CITY OF PORTLAND, MAINE
DEPARTMENT OF BUILDING INSPECTION

LOCATION 93 1/2 High Street OWNER _____

STATEMENT OF SPECIFICATION PERTAINING TO CHANGE OF USE OF PARTS
OF THE BUILDING AT 93 HIGH ST. FROM BUSINESS SCHOOL TO
CHURCH USE

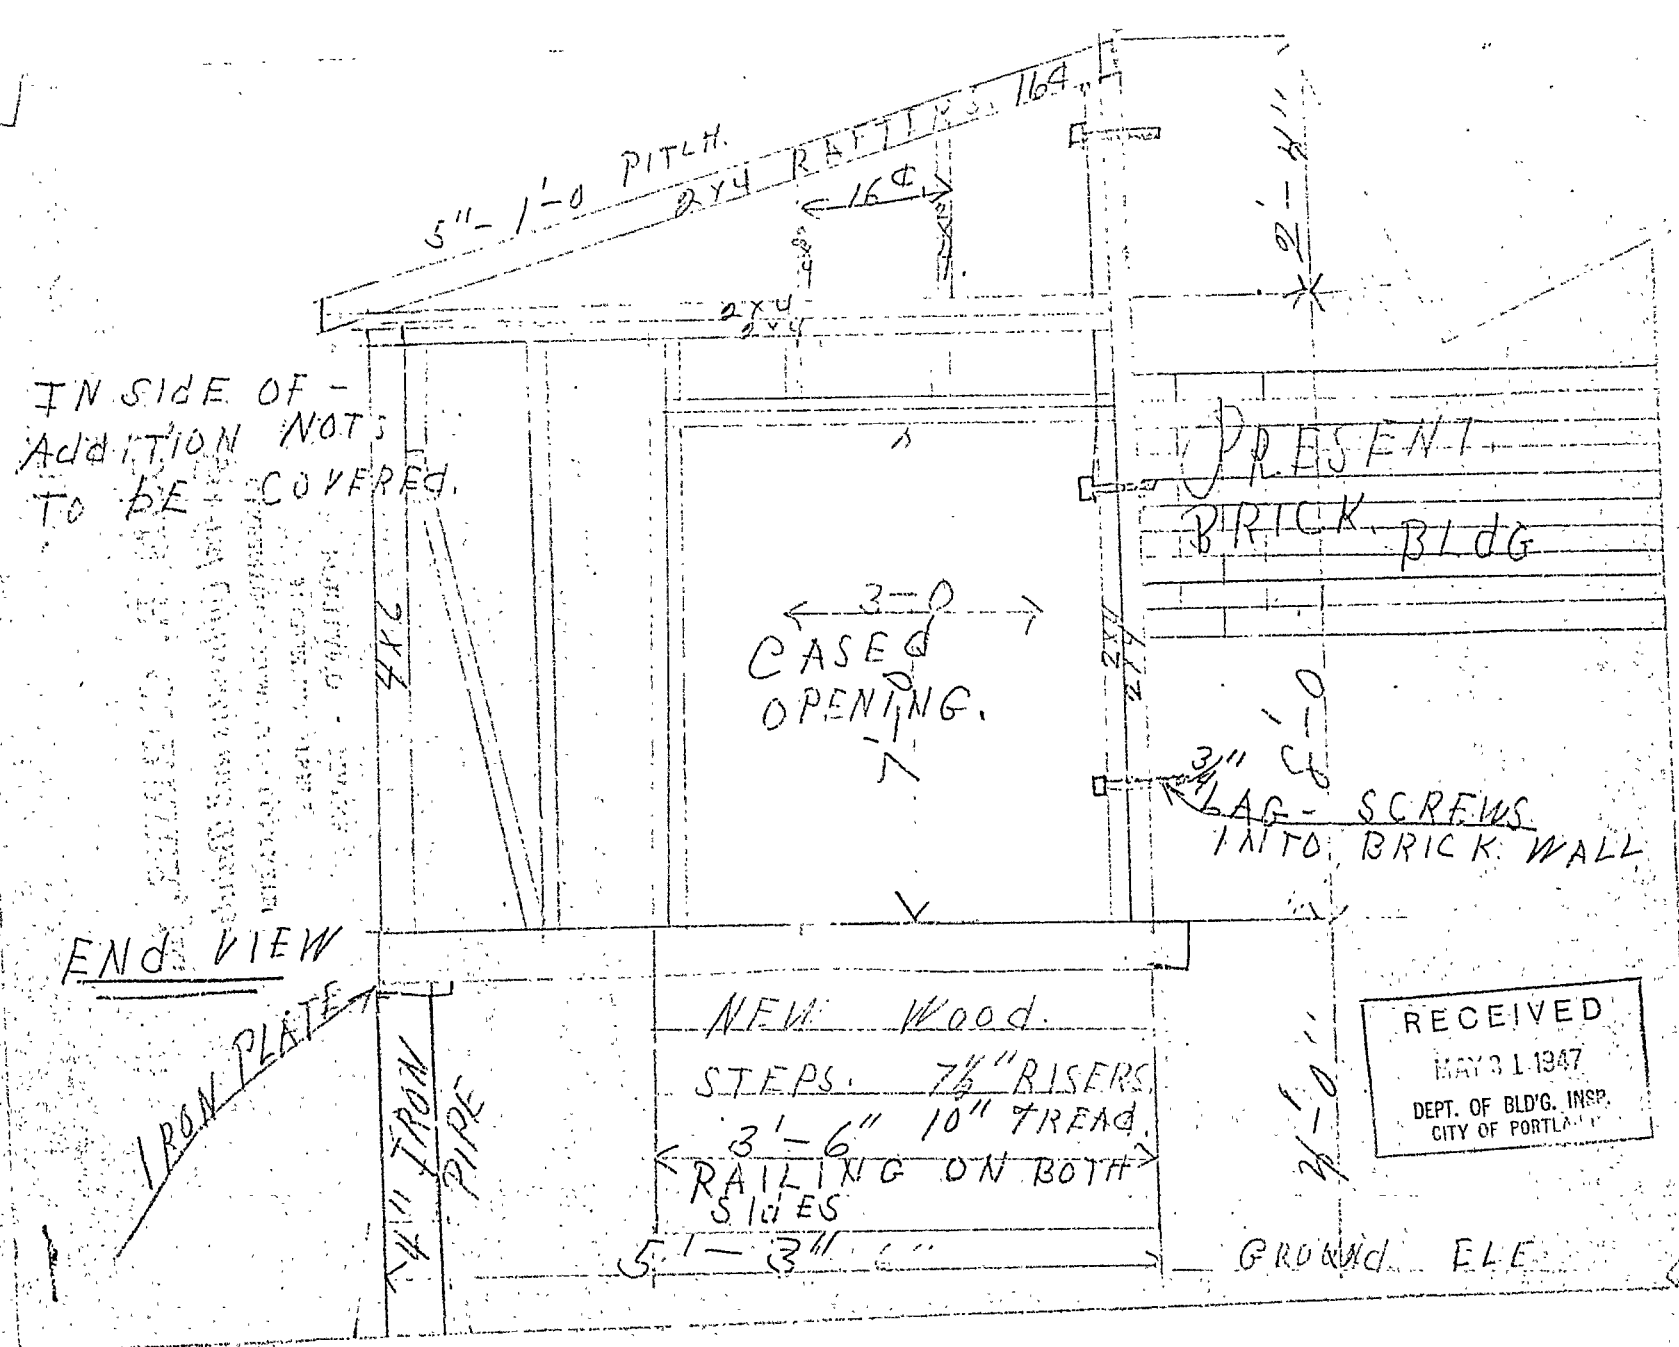
1. The first application for the permit indicated merely that an existing basement window was to be changed out to a door but later additional information showed that a door beside the cellar entrance evidently is intended of the bulkhead type with the exterior door in a vertical position. The application still does not show how big over this bulkhead is to be but merely that it will be 11' from the side lot line and 16' from the rear lot line, and that the bulkhead is intended to be of wooden frame construction.

2. If the above is the correct understanding, irrespective of the size of the bulkhead, the permit is not issuable for this frame construction within the limits of Fire District No. 1 where the property is located. See Section 402-a-1 of the Building Code which calls for Second Class Construction or more fire resistive construction. Second Class Construction means exterior walls to be of masonry but the roof may be of wooden frame construction, with cornice covered with metal.

3. If the change were made to masonry walls, the permit would not carry the right to use any part of the basement for students, it being my recollection that a certificate of occupancy for this building included use for the business college of only the floors above the basement and exclusive of the third floor. If it should be desired to use the basement for students, that fact should be stated in the application for the permit and with the application should be filed an architectural plan of the basement showing all features controlled by the Building Code and the improvements as to safety and fire protection required by the Building Code for this class of use. See Section 210.

4. If it were intended to use the basement for students, the bulkhead/would not only have to be of masonry but the exterior door, since it evidently would be closer than 20' to a private lot line would have to be a labelled Class B fire door set in structural metal frame. See Section 210-b-2.

5. The later information given indicates that the concrete foundation wall would be 6" thick at the top and 12" thick at the bottom. The minimum provided by the Building Code is 10" thick at the grade of the ground outside of the wall and 12" thick at the bottom.
